N1- CB19 3 WIRES

The release of the CB 19 occurred which replaces the CB 9 board. The features are similar to other Menu driven control boards.

○ **3 Wires wiring diagram:**

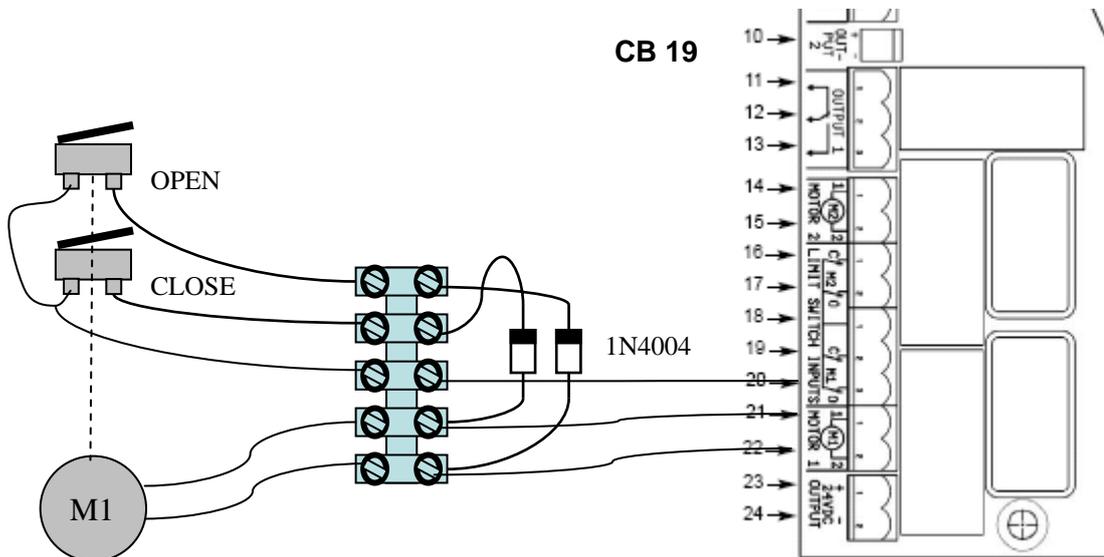
Some difficulties have been experienced with 3 wire systems. Boards require modification before these can be fitted. An update on firmware and hardware will be developed that will allow all CB19 to operate regardless on motor system. For now please order CB19 and ask for this modification to suit 3 wire systems.

Wiring details when using a terminal block for a 3 wire system. Duplicate for M2 wiring, see page 6 of the CB19 manual.
